LLOYD SQUARE, PROPOSED MINOR MODIFICATION

This minor modification reduces the total number of lots from 16 to 15. The revision prevents having to cross the minor intermittent stream at the southern end of the property and removes two affordable units (fee in lieu of these units is proposed).

LLOYD SQUARE SUBDIVISION

SITE AND UTILITY PLAN
CONSTRUCTION PLANS

C-3

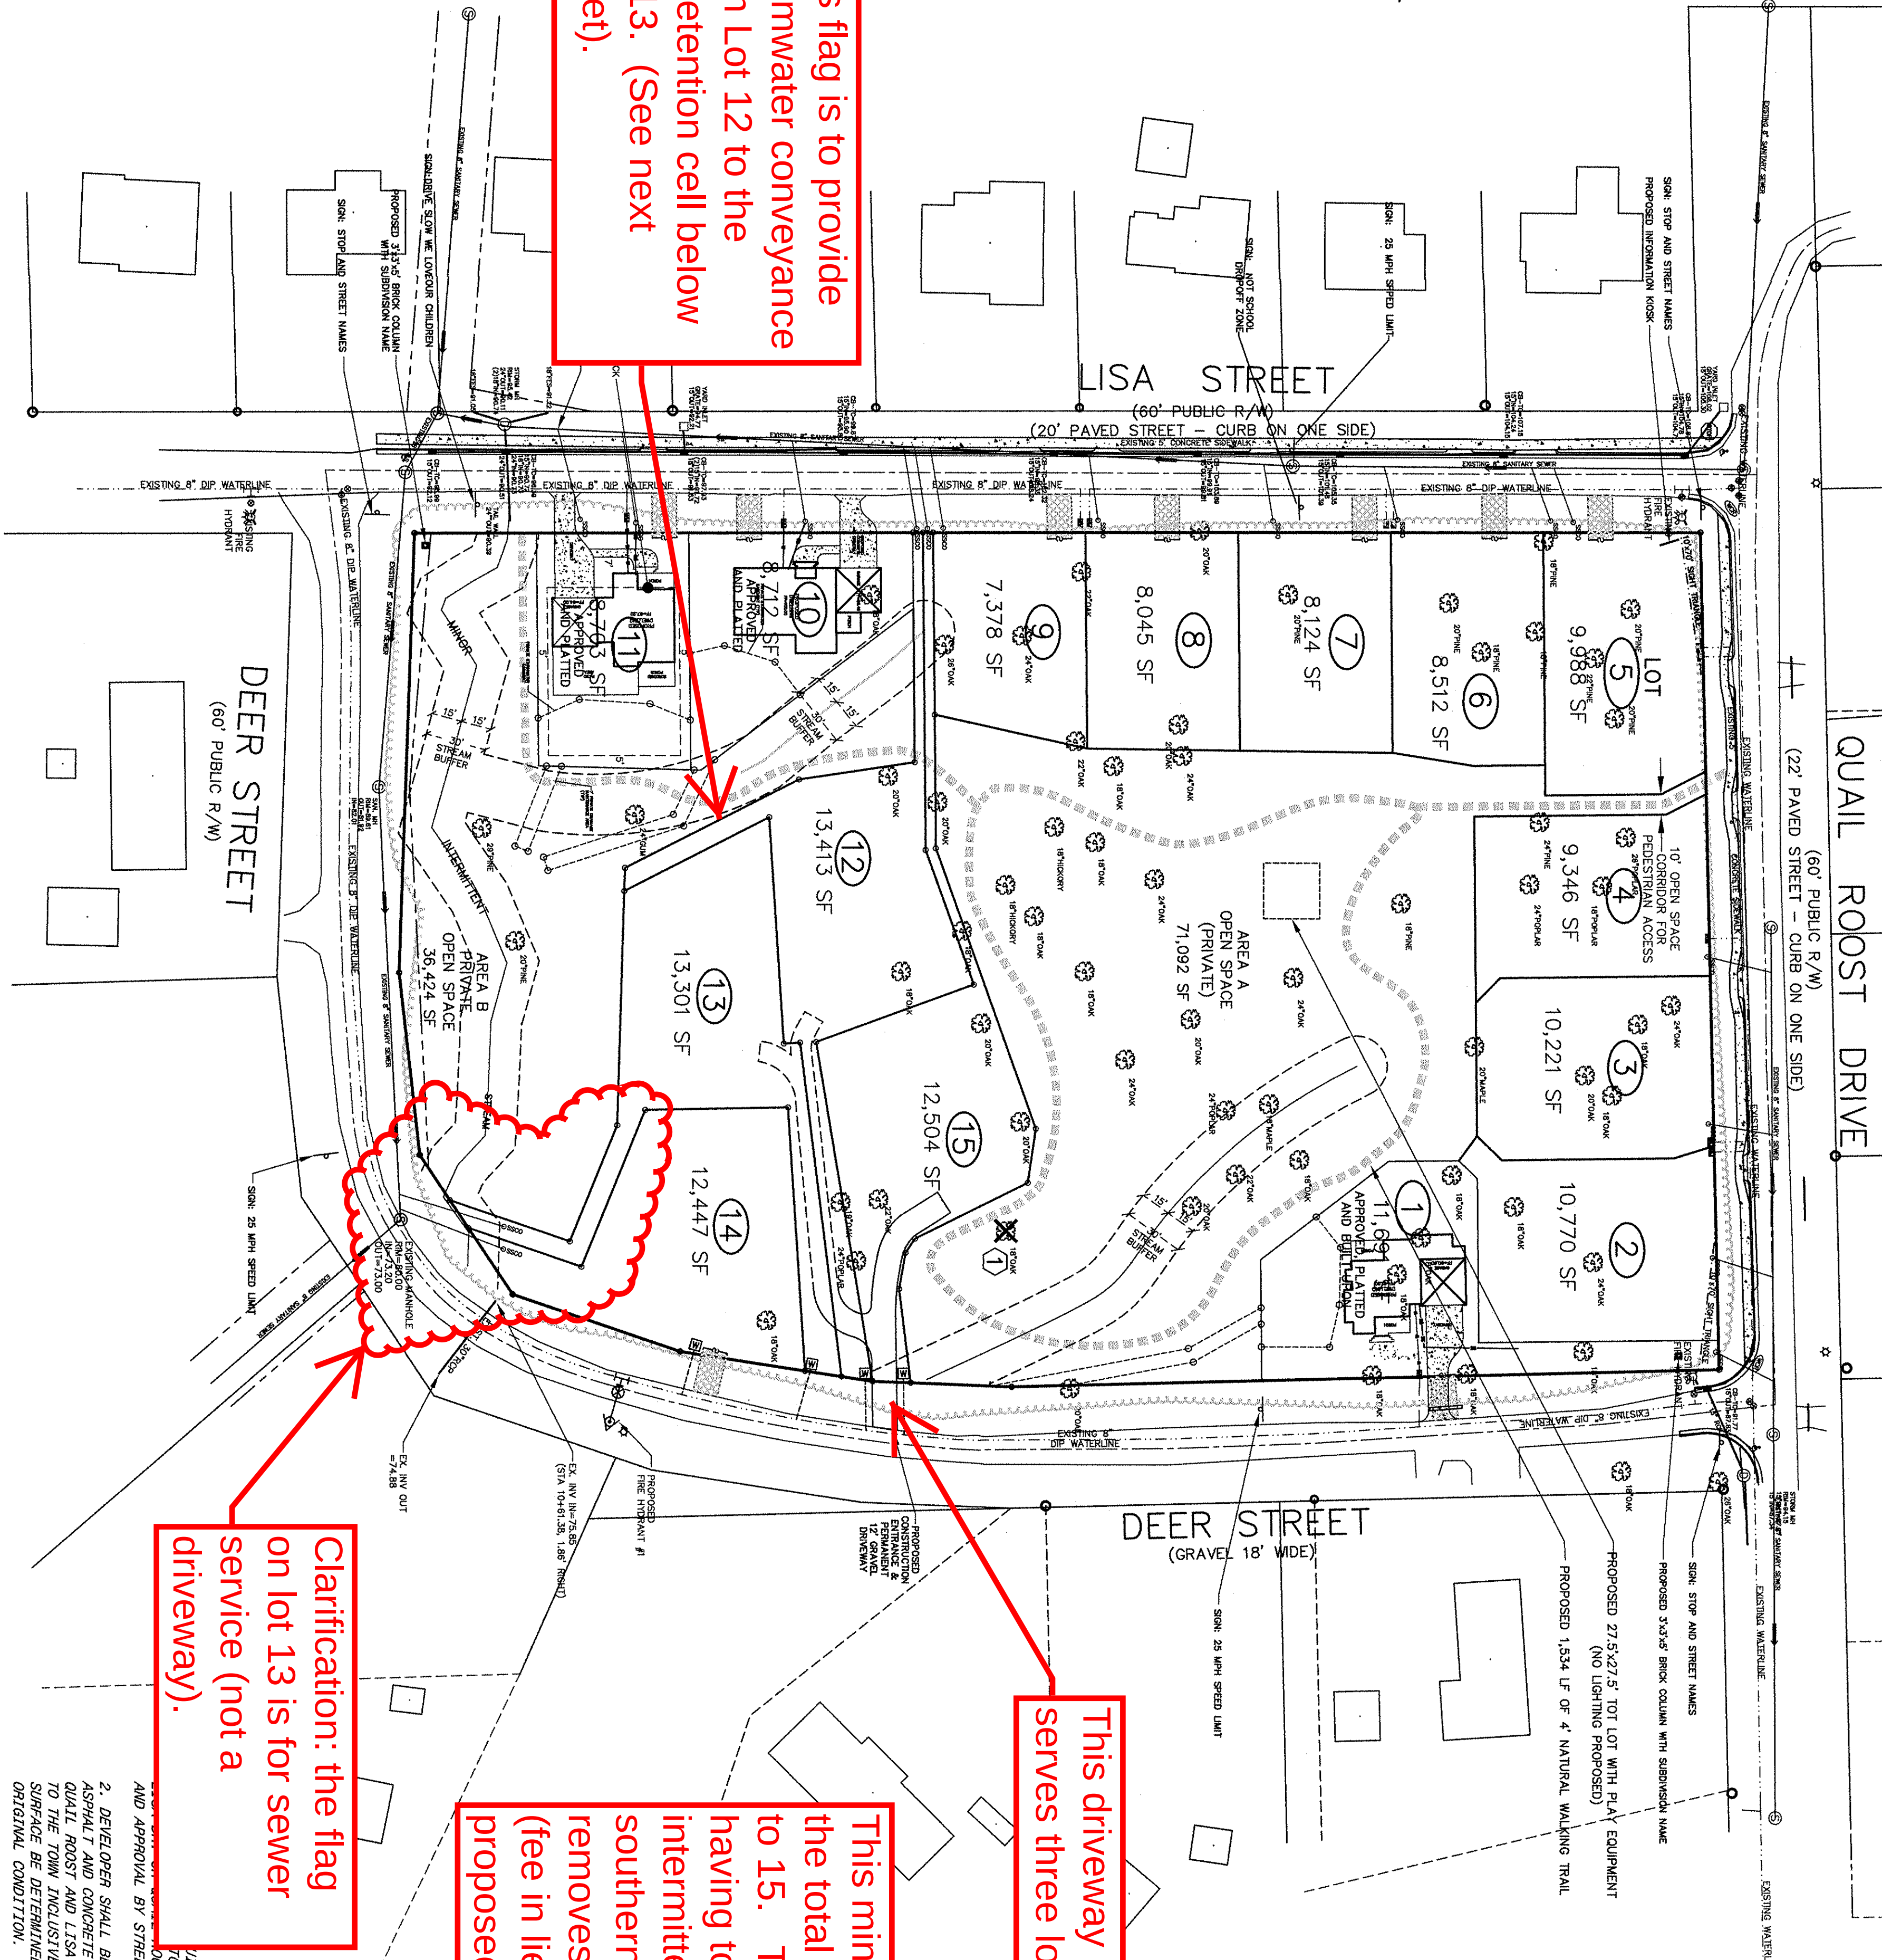
This flag is to provide stormwater conveyance from Lot 12 to the bioretention cell below lot 13. (See next sheet).

Clarification: the flag on lot 13 is for sewer service (not a driveway).

This driveway serves three lots.

REVISIONS	SHEET
	C-4
	OF 9

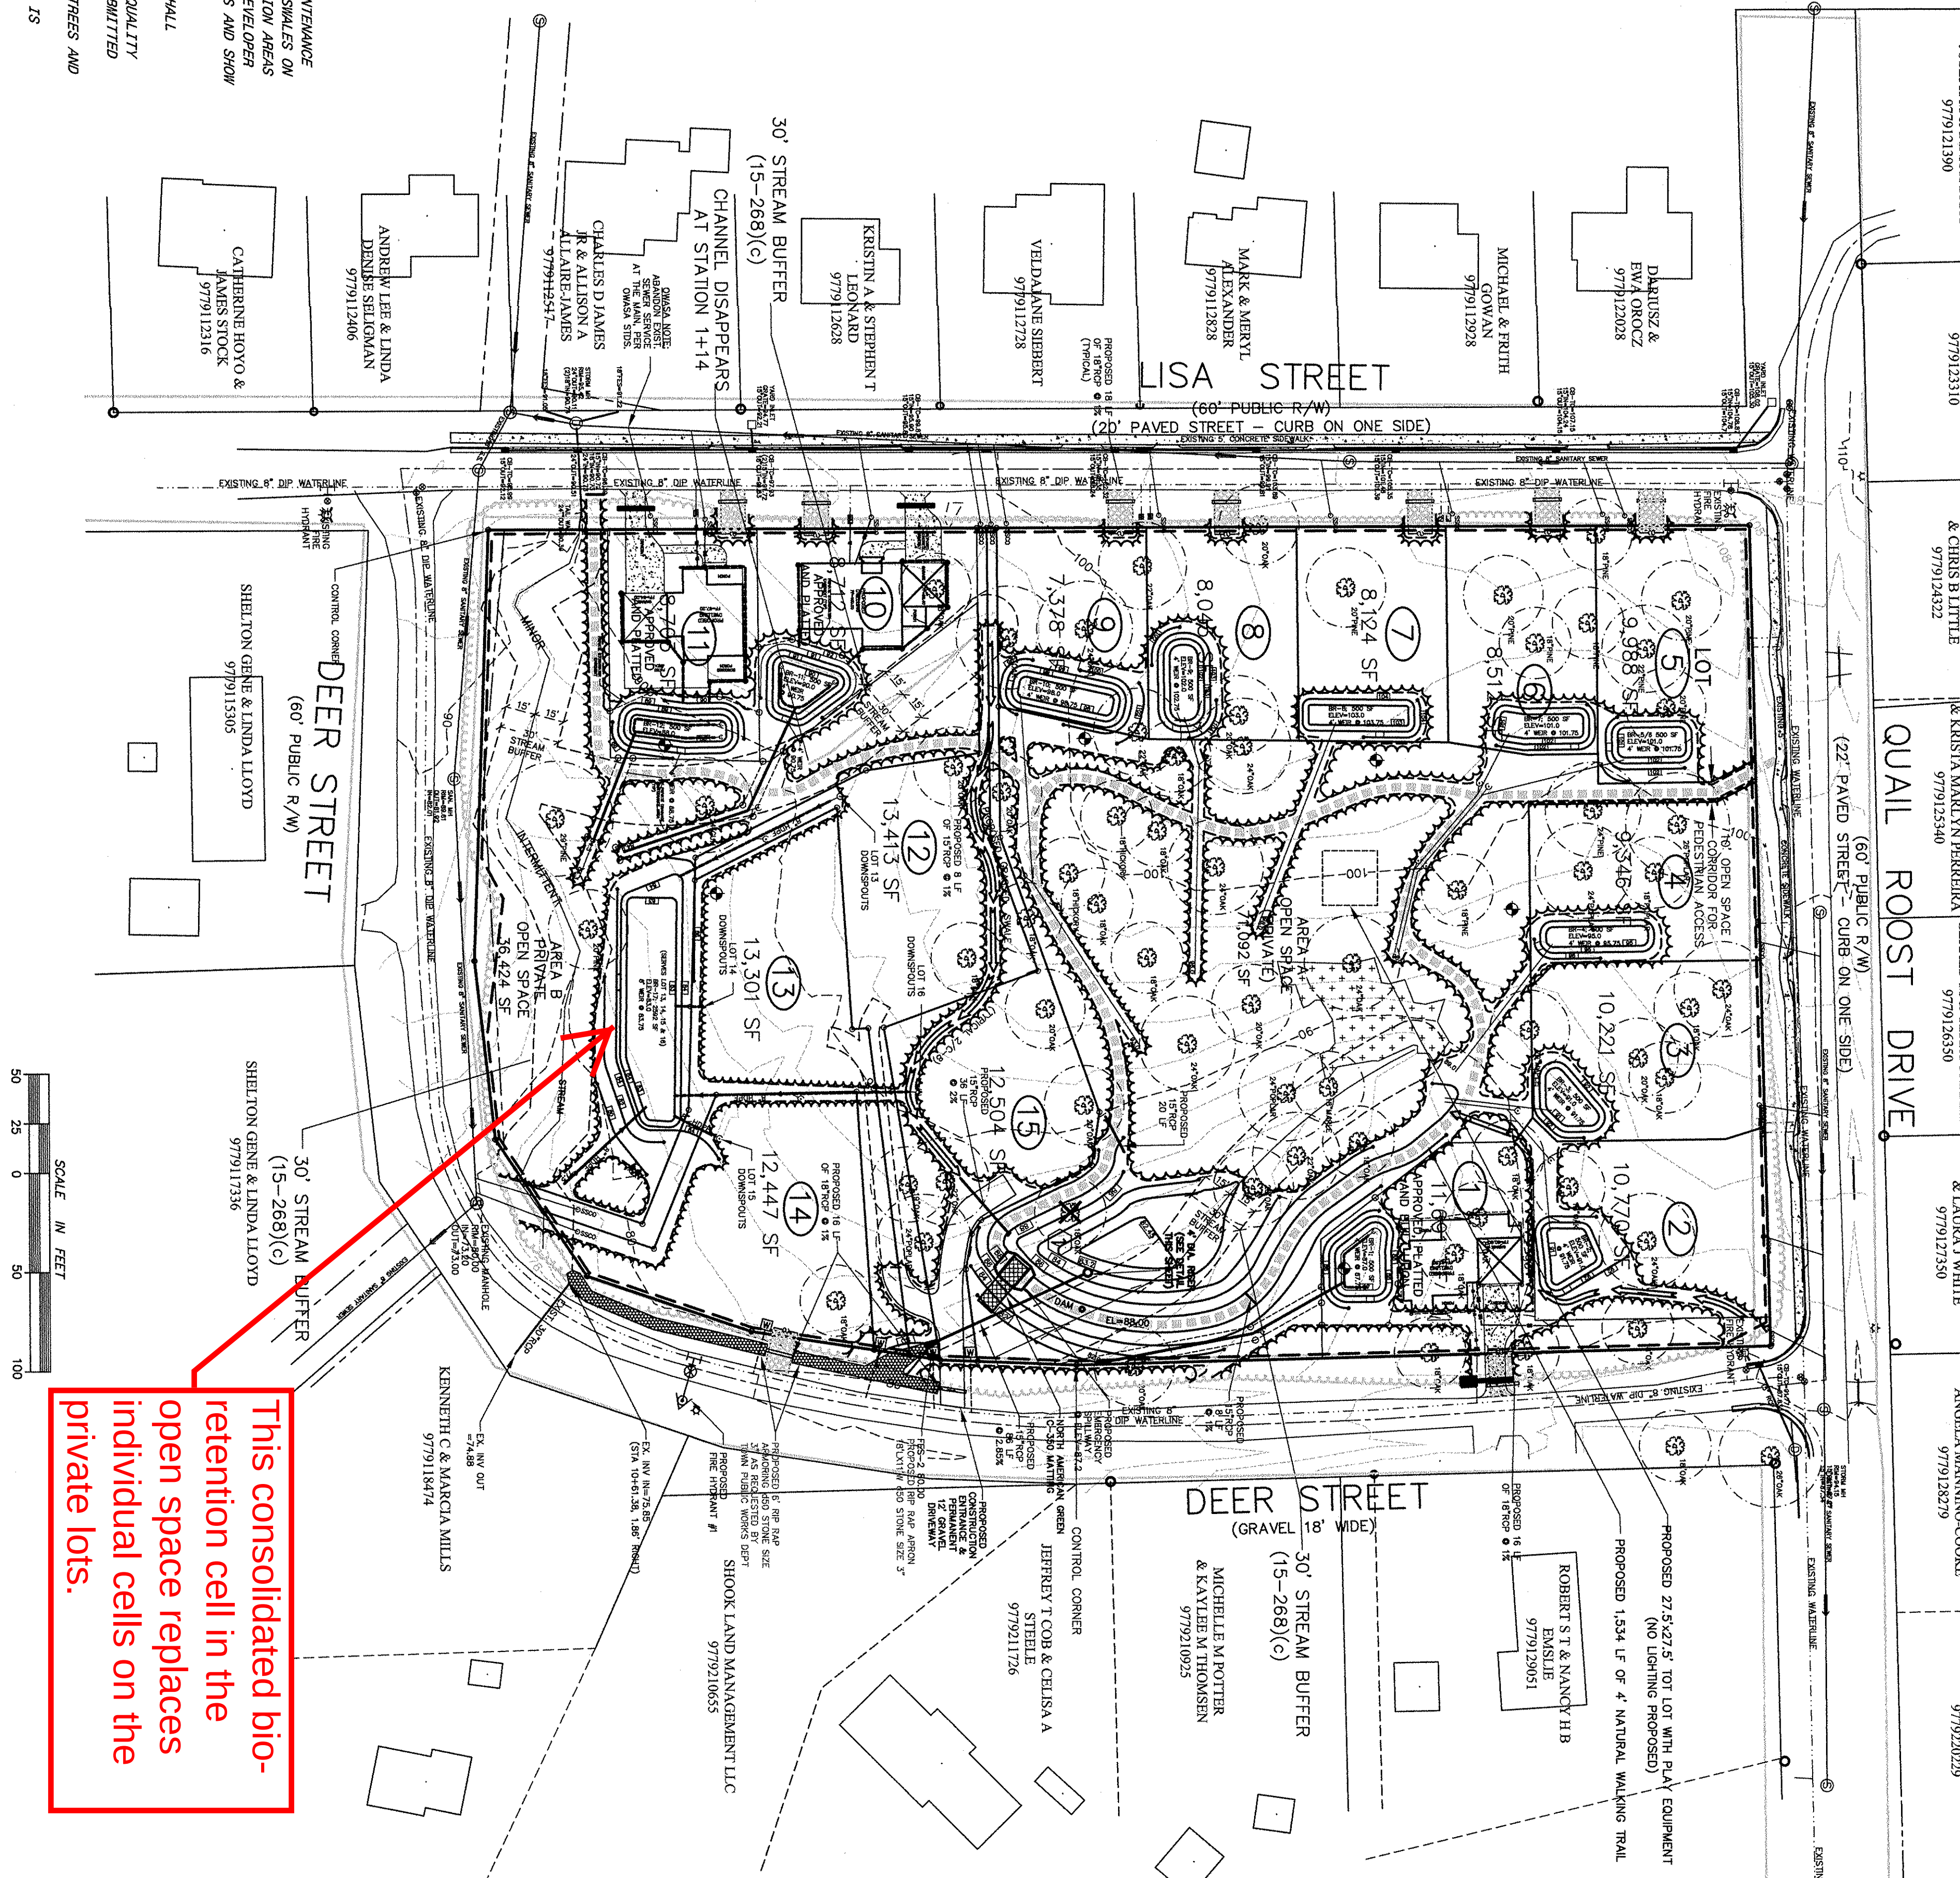
This consolidated bio-retention cell in the open space replaces individual cells on the private lots.
